Bocket
#50-346

A copy of a letter sent to the Toledo Edison Company, dated August 28, 1973, subject: Request for Additional Information for Davis-Besse Nuclear Power Station, was sent to you on August 30, 1973. The attached enclosure was inadvertently omitted, please attach. Thank you.

ENCLOSURE 1
REQUESTS FOR ADDITIONAL INFORMATION
TOLEDG EDISON COMPANY
DAVIS-BESSE NUCLEAR POWER STATION
DOCKET NO. 50-346

AUGUST 27, 1973

FIGURE 6.3.E-1

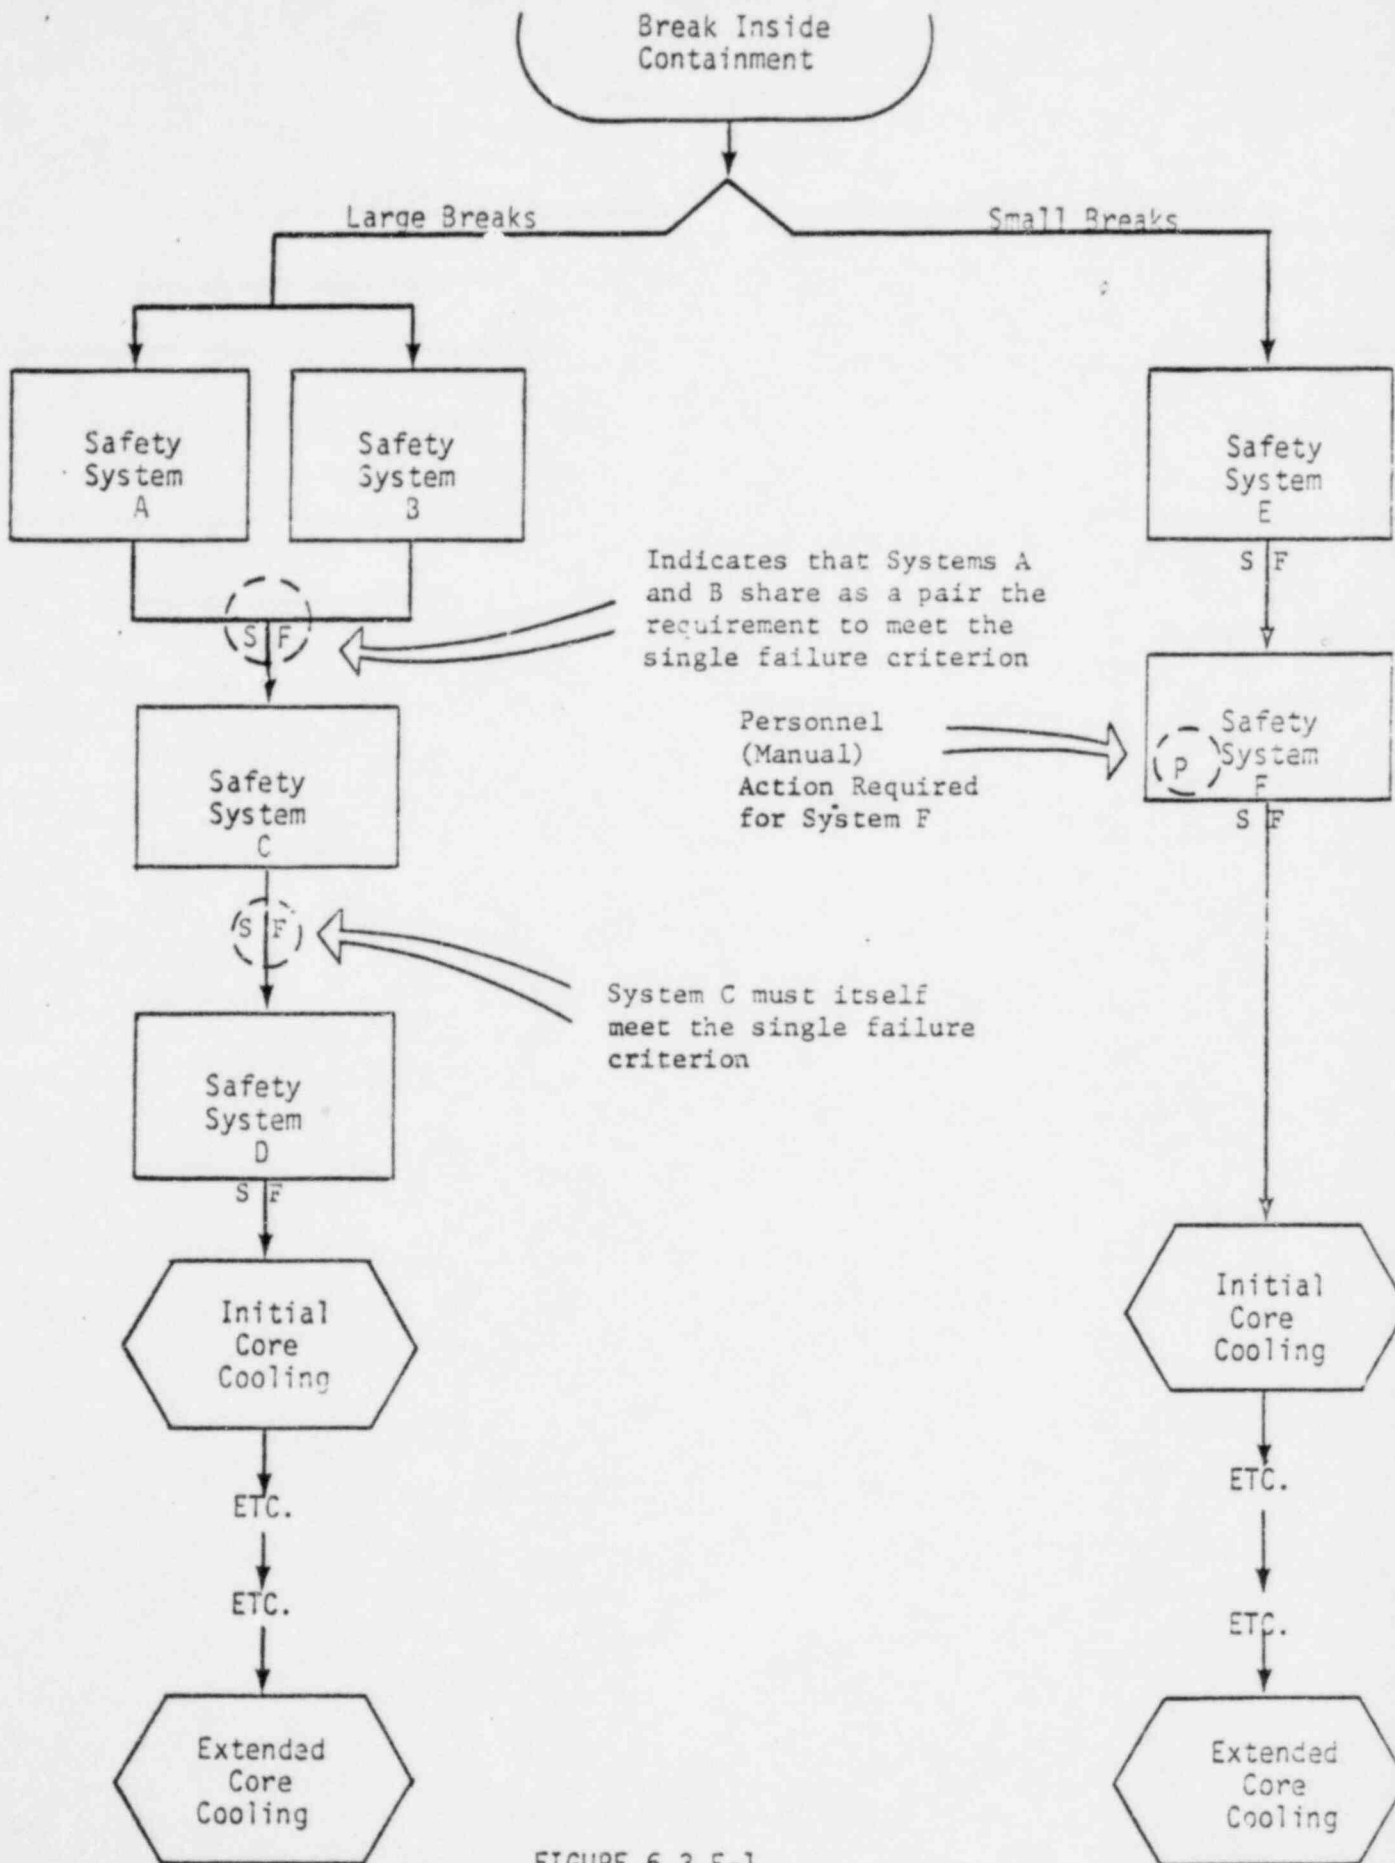
- 6.3.5 Item 6.3.2.11 of the "Standard Format and Content of Safety Analysis Reports for Nuclear Power Plants" (Revision 1, October 1972) indicates the need to distinguish between true redundancy incorporated in a system and multiple components. To complement the FSAR discussions in this regard, provide a summary of a systematic core cooling functional analysis of components required over the complete range of coolant pipe break sizes inside the containment. The summary should be shown in the form of simple block diagrams beginning with the event (pipe break), branching out to the various possible sequences for the different size breaks, continuing through initial core cooling and ending with extended or long-term core cooling. When complete, the diagram should clearly identify each safety system required to function to cool the core for all coolant pipe breaks inside the containment during any plant operating state. The attached Figure 6.3.F-1 is provided as a guide.

- 6.3.6 For each engineered safety feature identified in 6.3.5 above, list the auxiliaries required for its operation.
- 6.3.7 In light of recent operating experience in a PWR in which four out of a total of sixteen solenoid-operated air cylinder exhaust valves were discovered failed in main steam line isolation valves (one isolation valve rendered inoperable), discuss those features which minimize the potential for a similar common mode failure at Davis-Besse.
